UNITED STATES PATENT AND TRADEMARK OFFICE

APPLICATION NO.	FILING DATE	FIRST NAMED INVENTOR	ATTORNEY DOCKET NO.	CONFIRMATION NO.
10/706,894	11/13/2003	Iulia Rusu	IR-2389 (2-3731)	7760

Office Action Summary

EXHIBIT B

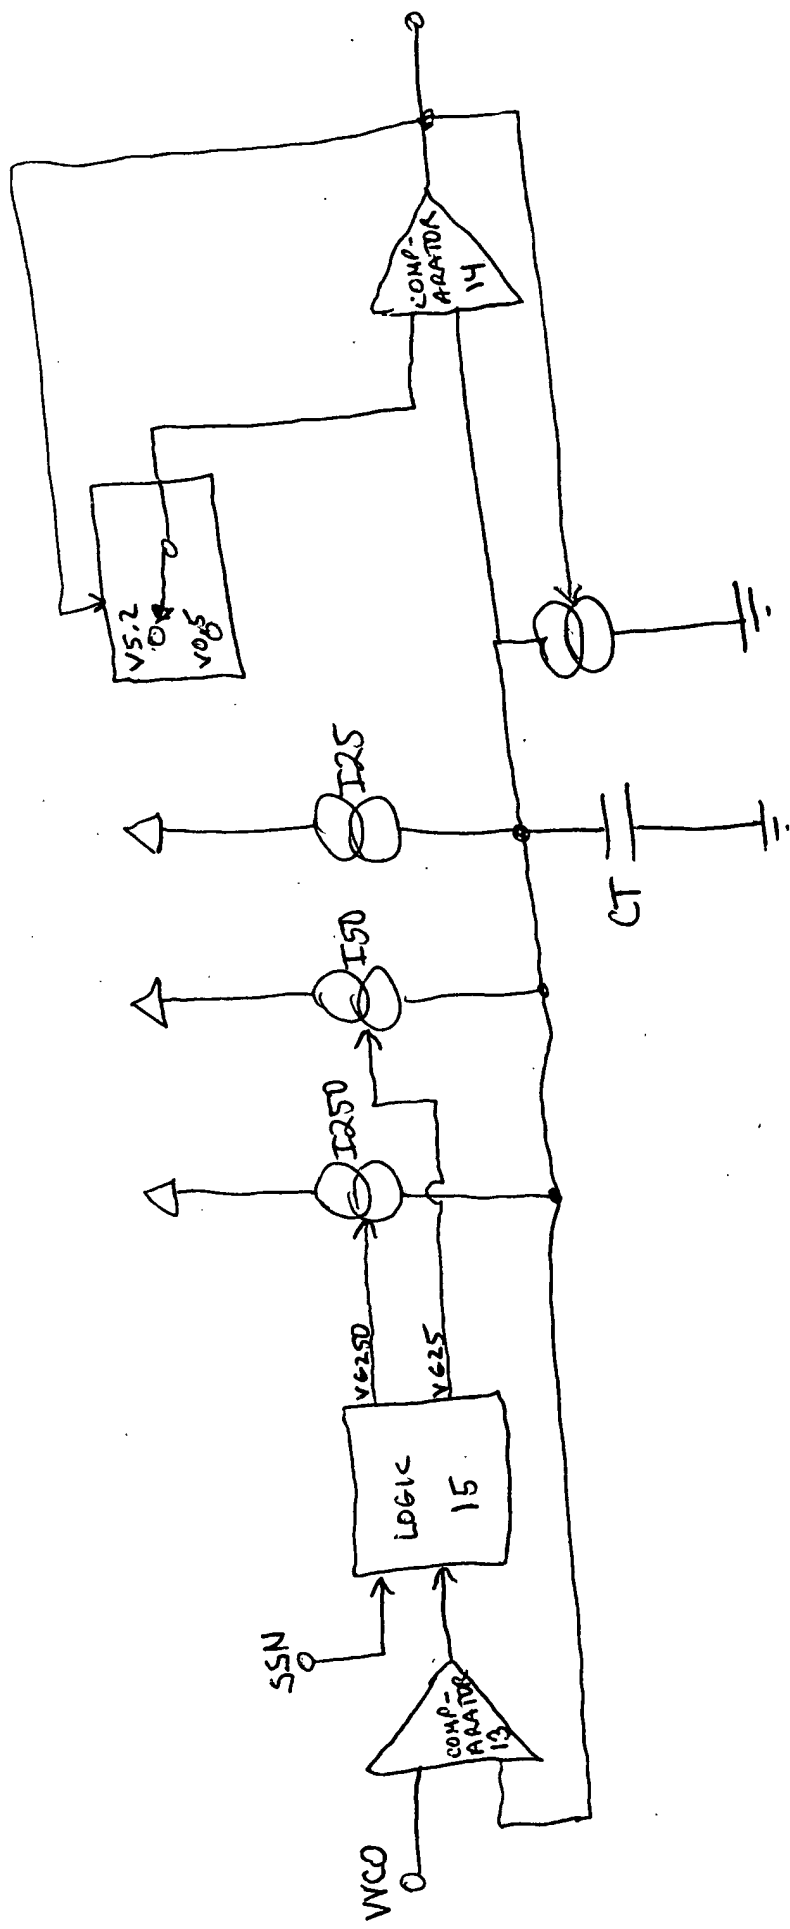
1. The drawings are objected to because:

In figure 1, several nodes are missing: 1) where I25 connects to CT, 2) where MP2 connects to I250 and 3) where the gate of the CT discharge transistor connects to the grounding transistor. See Exhibit B.

2. Exhibit A is a suggested drawing figure. A simplified circuit diagram similar to this is suggested.

Corrected drawing sheets in compliance with 37 CFR 1.121(d) are required in reply to the Office action to avoid abandonment of the application. Any amended replacement drawing sheet should include all of the figures appearing on the immediate prior version of the sheet, even if only one figure is being amended. The figure or figure number of an amended drawing should not be labeled as "amended." If a drawing figure is to be canceled, the appropriate figure must be removed from the replacement sheet, and where necessary, the remaining figures must be renumbered and appropriate changes made to the brief description of the several views of the drawings for consistency. Additional replacement sheets may be necessary to show the renumbering of the remaining figures. Each drawing sheet submitted after the filing date of an application must be labeled in the top margin as either "Replacement Sheet" or "New Sheet" pursuant to 37 CFR 1.121(d). If the changes are not accepted by the examiner, the applicant will be notified and informed of any required corrective action in the next Office action. The objection to the drawings will not be held in abeyance.
